Modifications for EMC3

Modifications List

Item 8: Fit two 10K resistor across pins 4 –1 and 4-3 of IC5

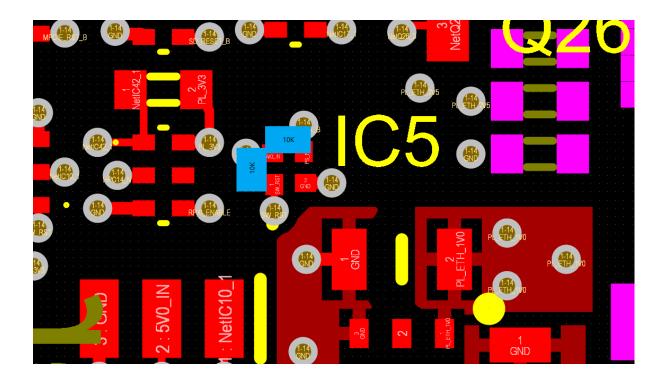
Item 7: Fit 10K resistor across pins 8 & 6 of IC123

This will disable a global reset on the peripherals and allow individual hardware and software peripheral reset

Item 9: Ethernet PHY for PS & PL requires NRESET to be pulled to 2.5V

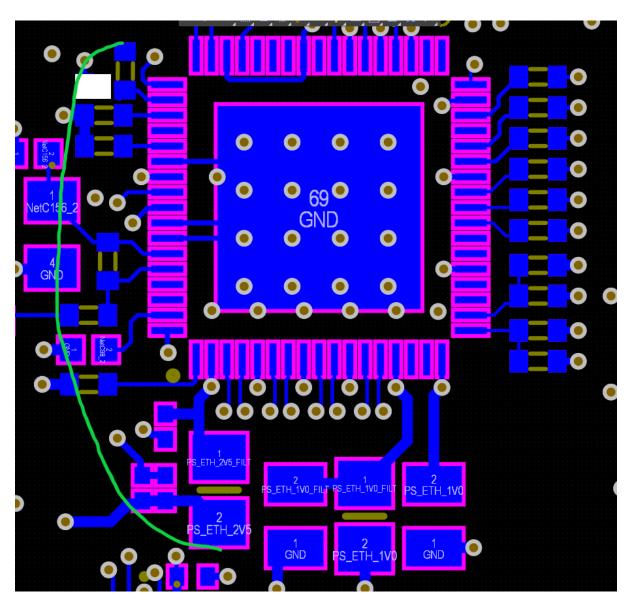
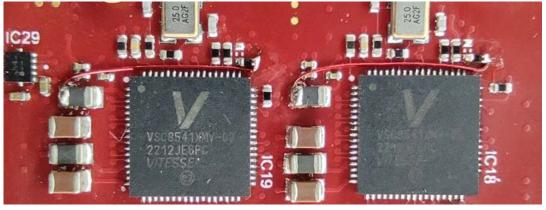
Currently the NRESET signal is tied to 1.8V, the I/O for the NRESET needs a voltage of 2.5V. Both PHY devices IC19 & IC18 require this mod. The modification requires rotating the R13 (PS) and R15 (PL) and connecting the end to a 2.5V supply using a wire. This is shown in the image below.

Item 10: Reset ICs require pull up resistor, on IC7 & IC10

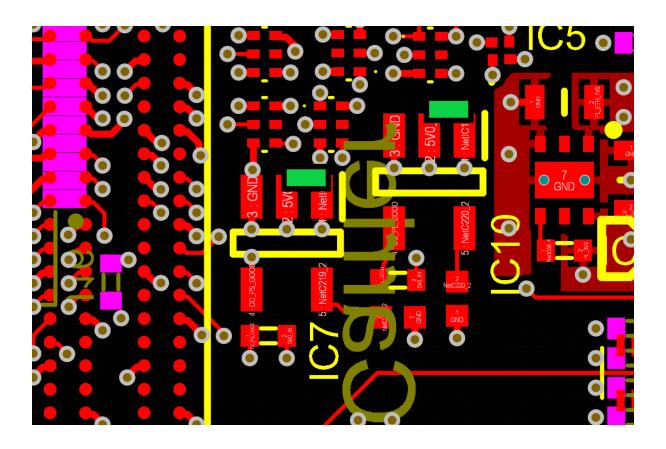
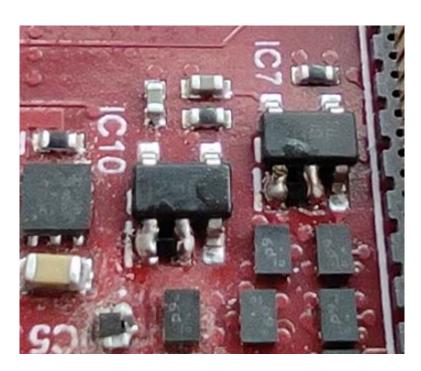
The reset IC require a pull up resistor between pins 1 & 2 on both devices. I fitted a 10K 0402 which fits well across the pins.

Item 11: RX CLK to RGMII requires clock pin, swap with RX CTRL

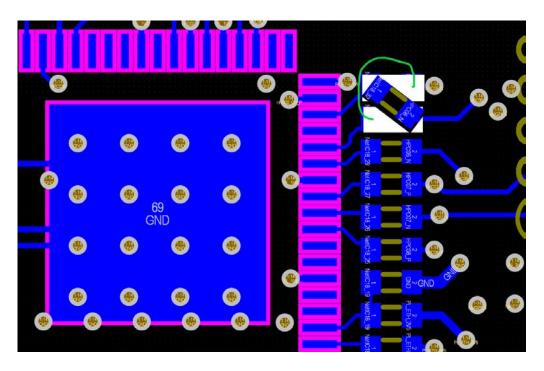
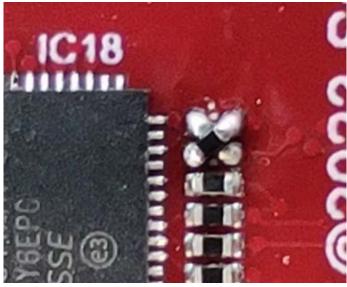
The RX clock from the PL PHY (IC18) is not on a clock capable pin for the FPGA and fails timing. The CLK and CTRL line can be swapped by;

- a. Removing resistors R102 and R104
- b. Placing a resistor "diagonally" on the pads between the RX CLK on the PHY and the clock pin of the FPGA
- c. Attaching a wire on the pads between the CRTL pin of the PHY and the spare FPGA input

This is shown in the image below, a wire is used to connect the CRLT signal. I used an OR 33r(?) 0603 size part, but I think an 0402 may be better.

Item 12: Attach wire for PCIe HOST clocks

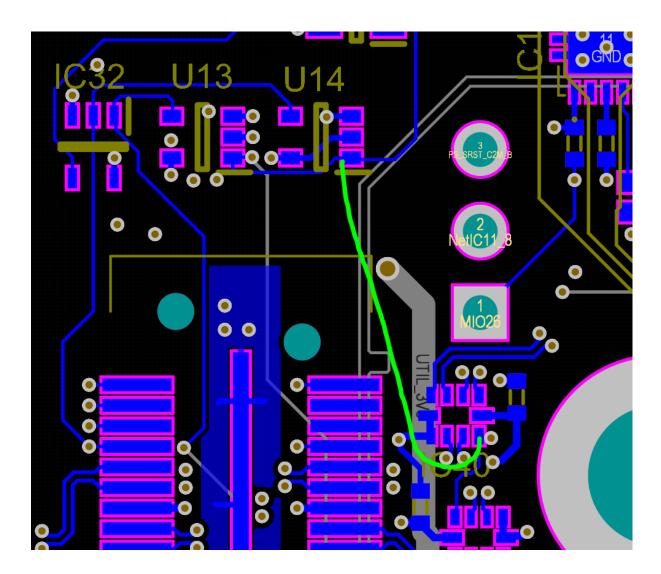
The switch signal for the PCIe clocks is floating, this needs to be attached by wire to a HOST_EN connection as indicted in the diagram below. Connection is from pin '1' of U14 to pin '9' of IC40.

Item 13: Pull ups for the UARTs.

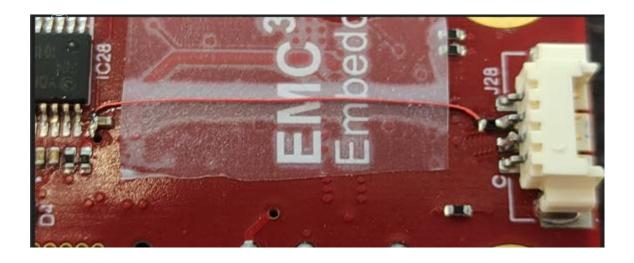
The UART needs a pull up on the TX line So, pin 3 needs 250R pulling up to 3.3V.

It's likely that the WIFI module will need it too. Again, a 250R to 3.3V:

Item 15: Remove 4x AND gates

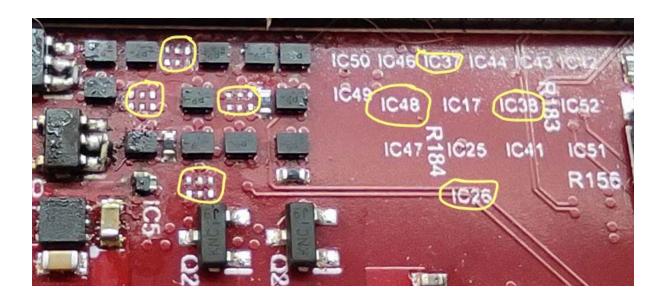
After more messing around, we (Emilie & myself) determined that the AND gates IC26, IC48, IC37 and IC38 were possibly bad and causing other problems.

They have been removed as all the control circuits for these have already been disabled already. It seems to have made things happier.

Item 16: File out a hole for the DP connector.

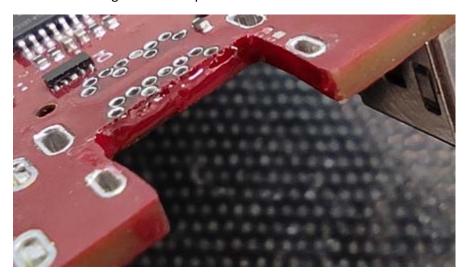
A slot needs filing for the DP connector to fit. There aren't any tracks in there but (after finding out the hard way), there are power planes, so its' best to make the hole slightly larger than needed and then coat the edge with some paint:

Let that dry, then fit the connector. Check the PL_3V3 power supply to ensure there are no shorts.

Item 17: Get the 100MHz clock generator working

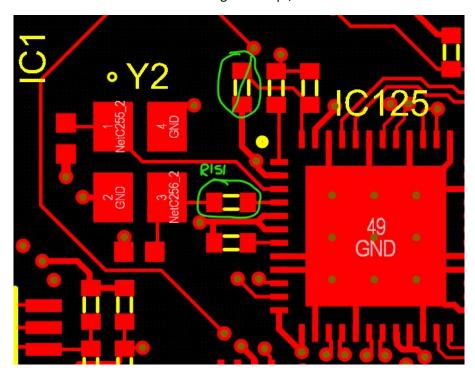
Remove resistor R264. This should have been a DNF all along.

Change R151 to 33R.

It's possible that C255 and 256 need to be changed to 18pf, but we're not 100% sure.

Item 18: Get a 3.3V clock for the USB hub.

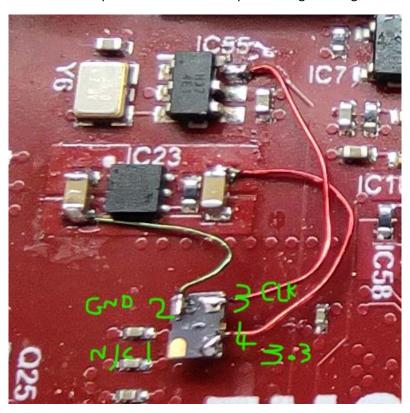
The USB hub needs a 3.3V 25Mhz clock. The one that is currently routed is only 1.8V, so doesn't have enough power.

Lift pin 6 on IC55 and then wire up an oscillator so it outputs the right voltage:

Grab a ECS-2520MV-250-CN-TR osc from the kit (Y6) and wire it as below.

Pin 1 is not connected.

Pin 2 is ground.

Pin 3 is the clock output – Pad 6 of IC55.

Pin 4 is 3.3V in.

Item 19: USB bits.

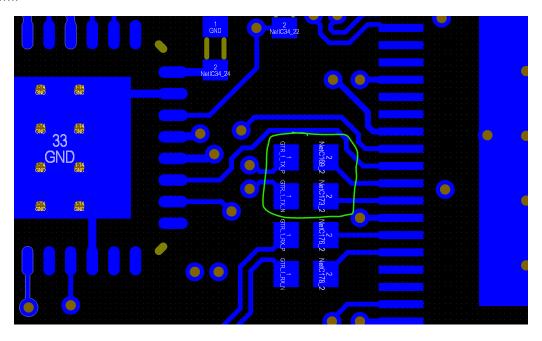
Change C169 and C173 to OR resistors. These are between the USBPHY and the USB hub chip on the bottom.

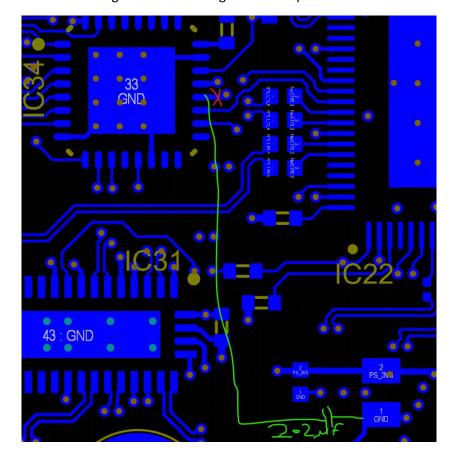
Disconnect pin 20 on IC34 and ground that through a 2.2Uf cap.

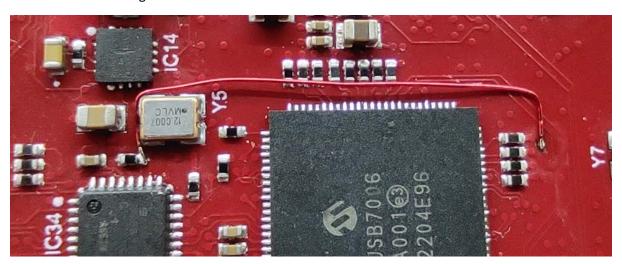
Link the USB PHY's reset to MIO43:

There is a via to the right of the resistors there.

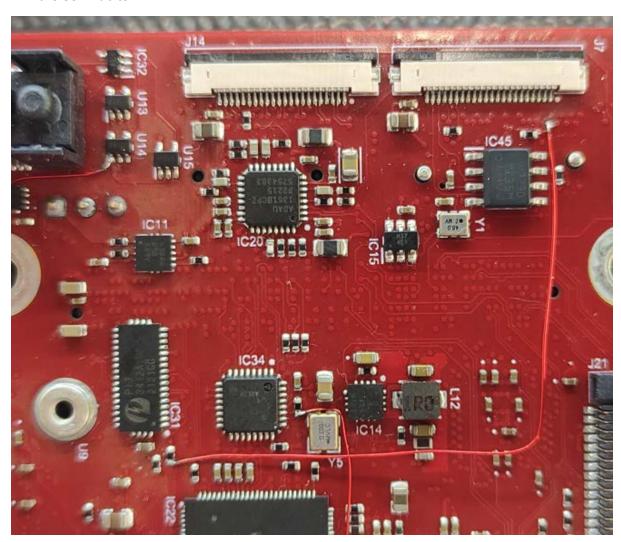
Link the USB Hub to HDA17:
